## **SOLLIE OAKS SUBDIVISION, NGUYEN ADDITION TO**

APPLICATION NUMBER 5 DATE May 15, 2008

REQUEST Subdivision

# DETAIL SITE PLAN

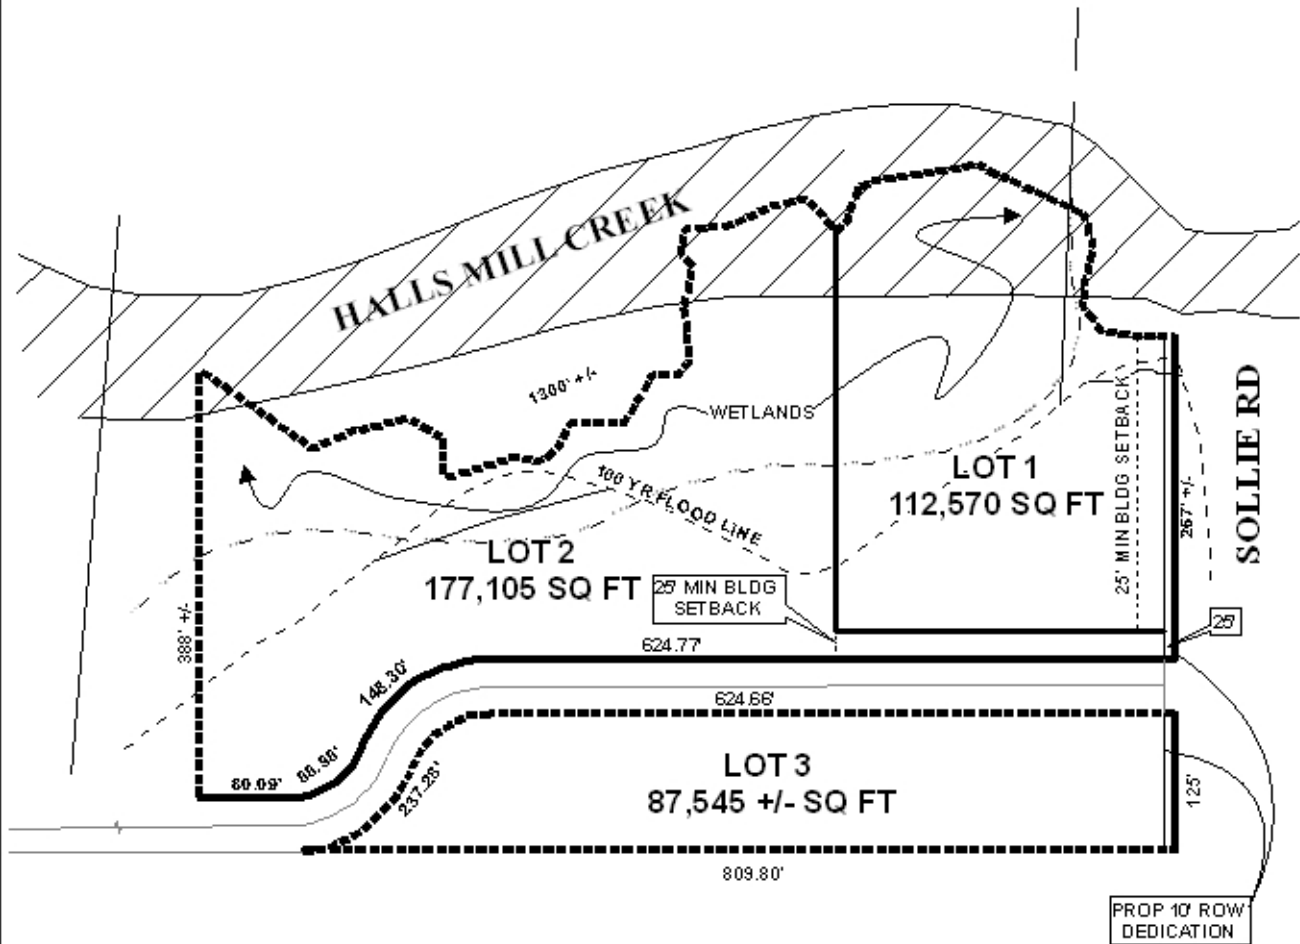
The plat illustrates the proposed 6.7± acre, 2 lot subdivision, which is located on the West side of Sollie Road, 866'± South of the North line of Section 18 – within the planning jurisdiction. The applicant states the site is served by city water and sanitary sewer.

The purpose of this application is to create two legal lots of record from a metes and bounds parcel. It appears that the parcel was illegally divided out in 2006. The plat should be revised to include the remainder of the parent parcel in the subdivision. Furthermore, the parent parcel was included in the Sollie Oaks Subdivision, which was approved by the Planning Commission in its April 17, 2003 meeting, as proposed Lots 3 and 4. Lots 1 and 2 of Sollie Oaks were recorded in February of 2004 with the remainder (lots 3 and 4) labeled as future development. It should be pointed out that “lot 4” of the previous application was shown as “future development,” but in fact had and still has a single-family residence, thus is already developed. There was no extension filed, thus the approval has expired. It is recommended that this application be held over to allow the applicant to revise the plat to include the entire parcel in the subdivision or provide planning staff with a letter stating the owners of the remaining property do not wish to participate in the subdivision process.

- 1) revised plat to include the remainder of the parent parcel in the subdivision; and
- 2) submittal of new labels and postage required to re-advertise.

postage along with a letter from the additional property owner stating that they did not wish to participate in the subdivision, however since the additional property owner was the cause of the creation of the child parcel, he will be required to participate in the subdivision process or the application should be denied. Additionally, the applicant did not include the remainder of the child parcel, bringing about additional reasons for the application to be denied.

- 1) the applicant did not include the parent parcel in the subdivision application; and
- 2) the applicant did not include the entirety of their parcel in the subdivision process.

- 1) the applicant did not include the parent parcel in the subdivision application; and
- 2) the applicant did not include the entirety of their parcel in the subdivision process.
